TITLE 326 AIR POLLUTION CONTROL DIVISION

Proposed Rule
LSA Document #11-356**DIGEST**

SUMMARY/RESPONSE TO COMMENTS FROM THE SECOND COMMENT PERIOD

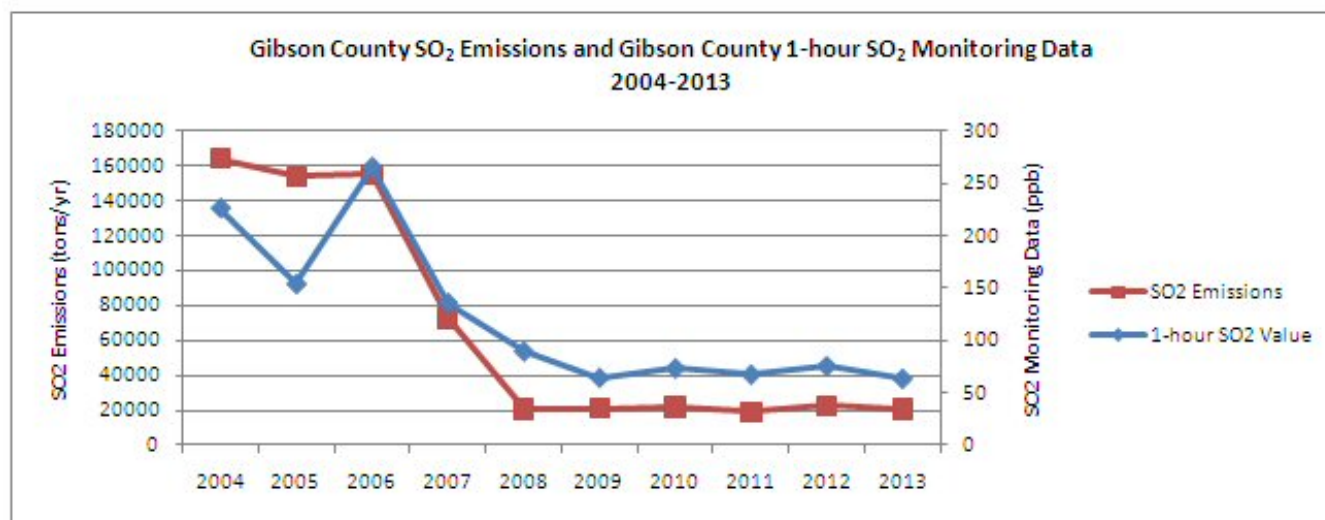
Comment: In its May 2011 preliminary designations for the 2010 SO₂ NAAQS, IDEM included the Gibson generating facility in its list of sources contributing to nonattainment in Southwest Indiana. The Gibson facility was subsequently removed because data from a monitoring station showed compliance at that specific location only. Air dispersion modeling (provided as an exhibit to the comment letter) performed on Sierra Club's behalf shows that based on either currently allowable emissions, or measured actual emissions, the Gibson facility causes SO₂ impacts that exceed the 2010 SO₂ NAAQS. When modeling allowable emissions, the analysis shows that the Gibson facility, on its own, violates the 2010 SO₂ NAAQS in a portion of the designated nonattainment areas in Southwest Indiana. IDEM must ensure that the entire nonattainment area in Daviess and Pike counties achieves compliance with the 2010 SO₂ NAAQS, not just at a specific monitoring location. On the basis of this alone, IDEM must impose SO₂ limits on the Gibson facility in this rulemaking. IDEM's responsibility under the CAA and the Indiana SIP is broader than simply ensuring compliance with the 2010 SO₂ NAAQS within the areas already designated as nonattainment. When modeling with allowable or actual emissions, the Gibson facility violated the 2010 SO₂ NAAQS over a broad swath of Southwest Indiana. IDEM should ensure attainment of the 2010 NAAQS throughout this area. (SC)

The 1-hour SO₂ design values measured at the Gibson Coal Road SO₂ monitor, located downwind of Duke-Gibson, have trended downward over the past several years and when U.S. EPA made its final 1-hour SO₂ nonattainment area designations, the 1-hour SO₂ design value at the Gibson County monitor registered below the 1-hour SO₂ NAAQS of 75 ppb. SO₂ emissions from sources within Gibson County have trended downward over the past 10 years, reflecting emission reductions resulting from state and federal rulemakings. Significant reductions in SO₂ emissions occurred in 2007 and 2008 and have remained at lower levels. The 99th percentile of the 1-hour SO₂ monitoring data taken from the Gibson County monitor has drop dramatically over the same time period as well. SO₂ monitoring data and SO₂ emissions for Gibson County correlate very well over the past 10 years, as shown in the chart below.
